**RE: Lot 12 Block 2 Unser Cliffs SAD 227
5631 Cinder Cone NW
Grading and Drainage Plan
Engineers Stamp Date 1/19/18 (E10D042)
Pad Certification Date 2/9/18**

Based upon the information provided in your submittal received 2/9/18, this plan is approved for Building Permit.

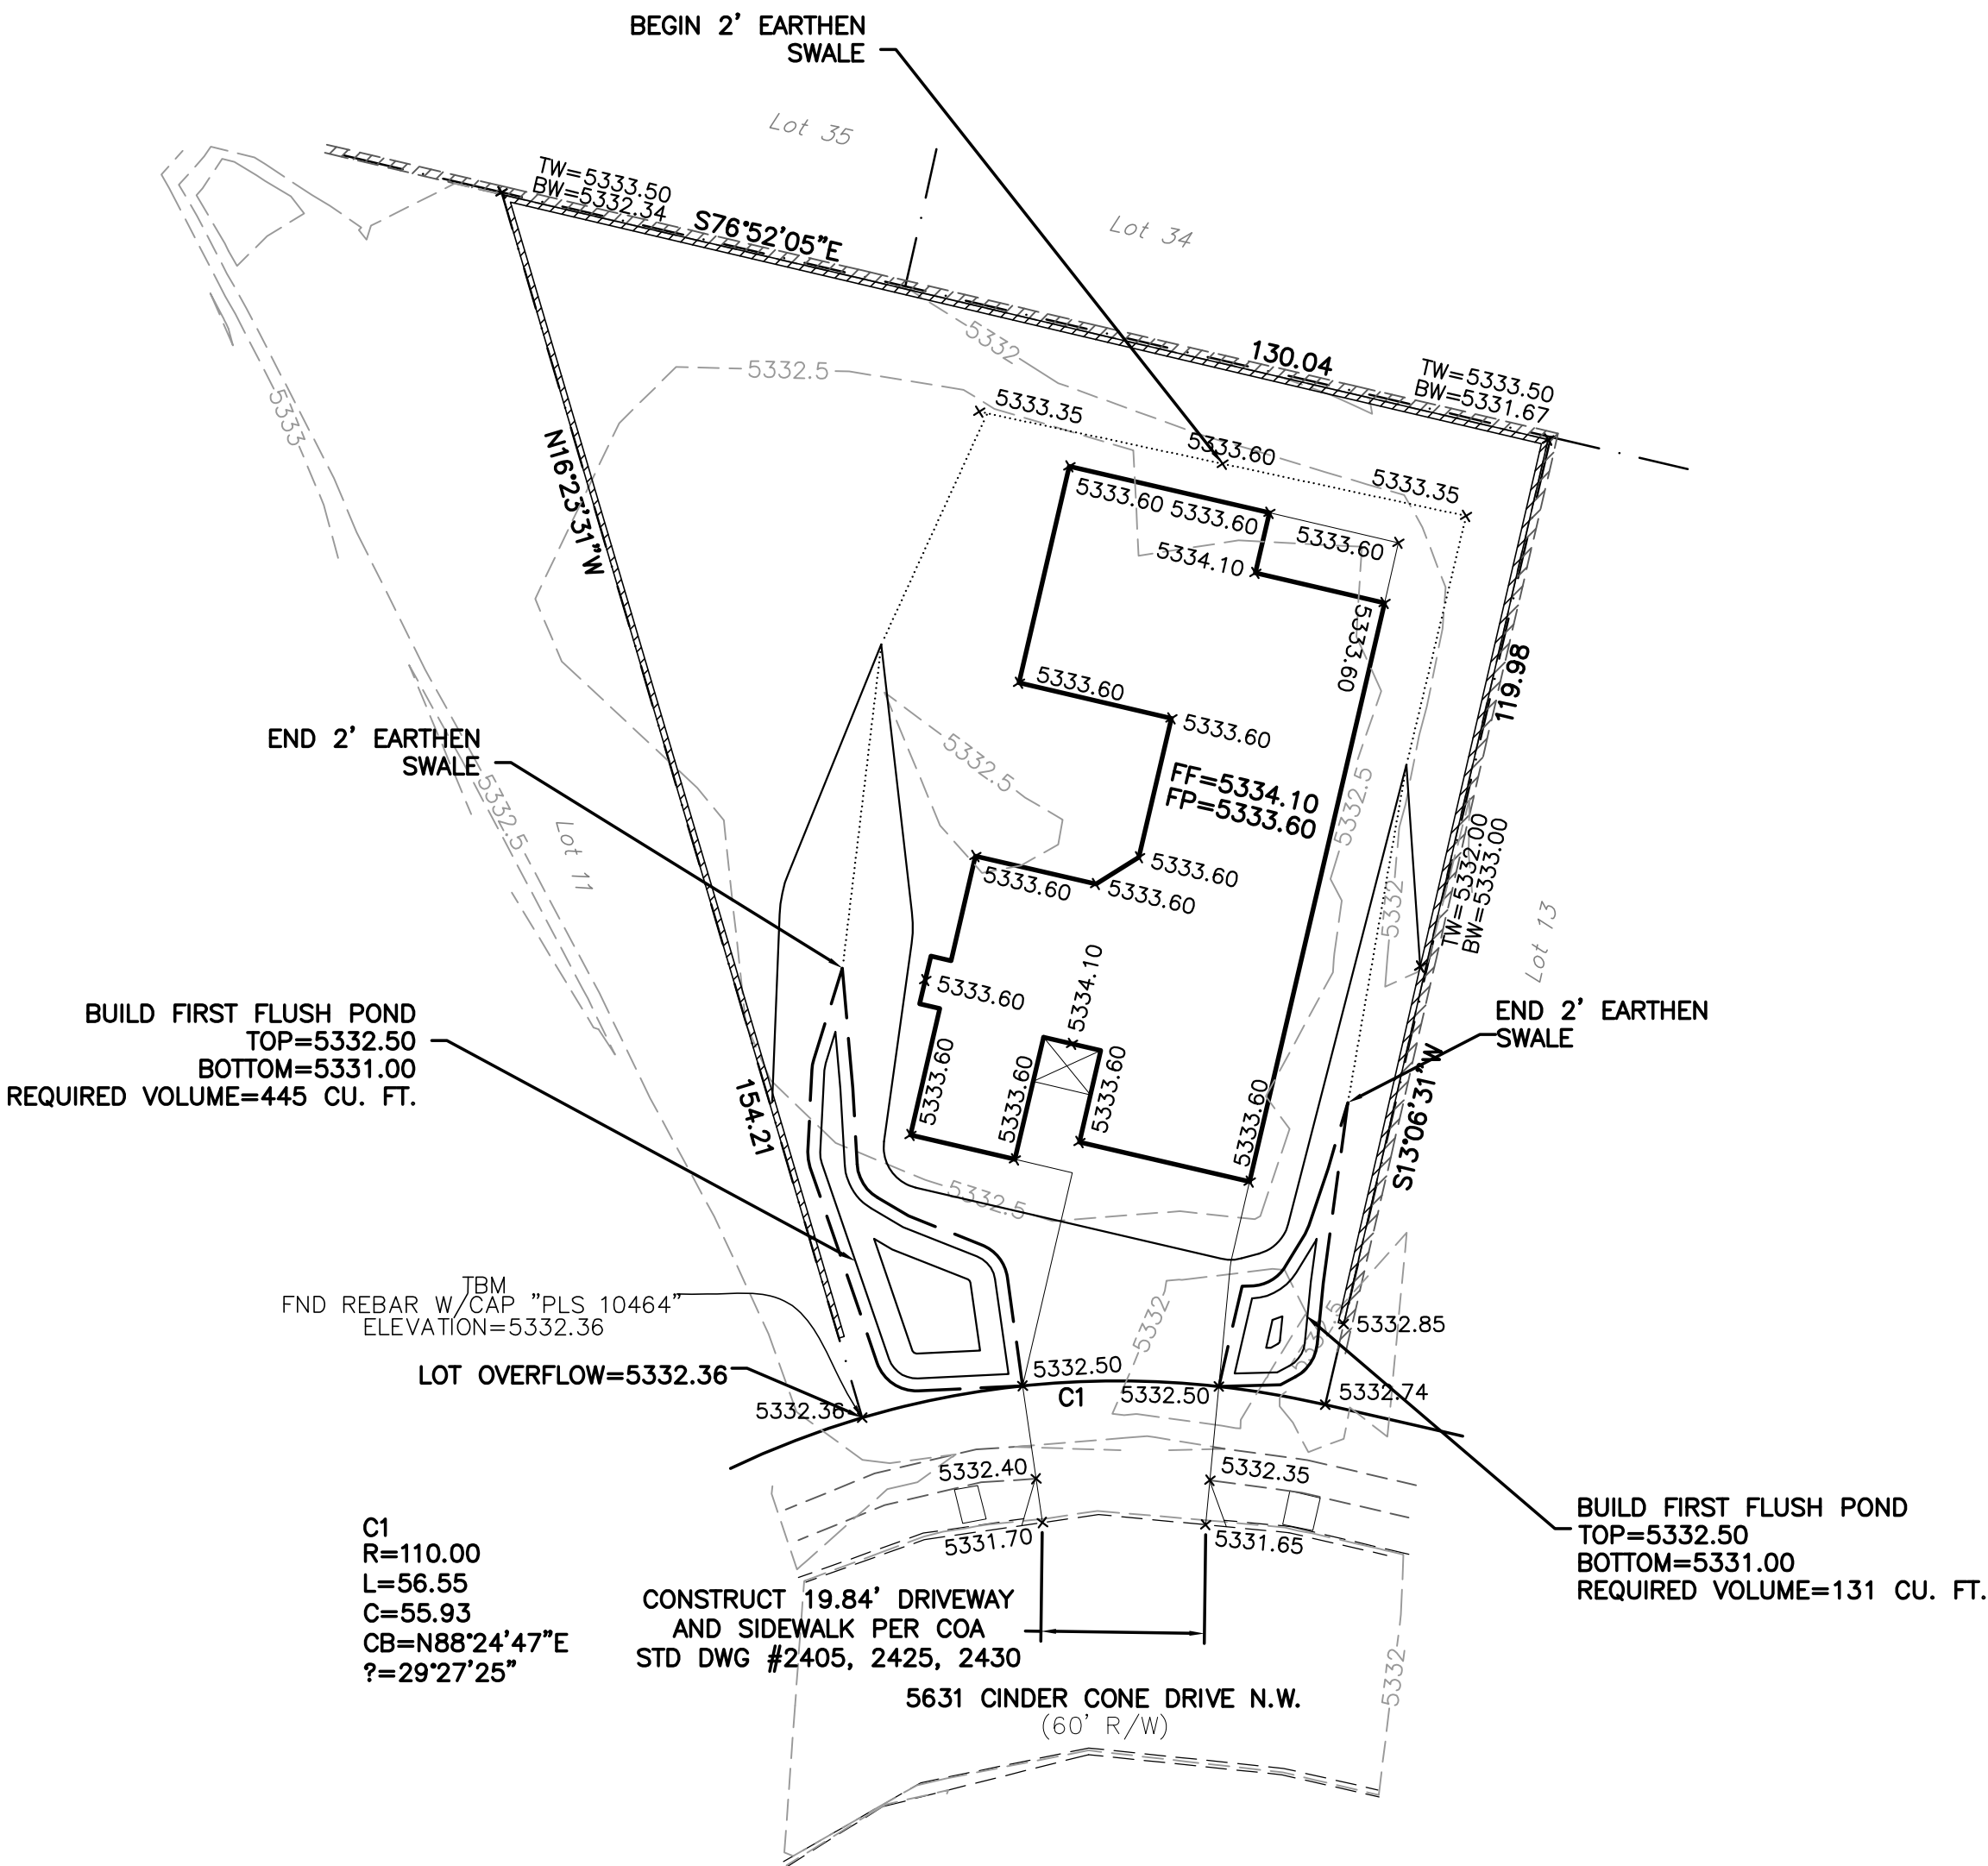
Reiterate to the Owner/Contractor that a separate permit for a garden/retaining wall must be obtained, with the approved G&D plan dated 1/19/18.

Prior to Certificate of Occupancy release, Engineer Certification per the DPM checklist of this plan will be required.
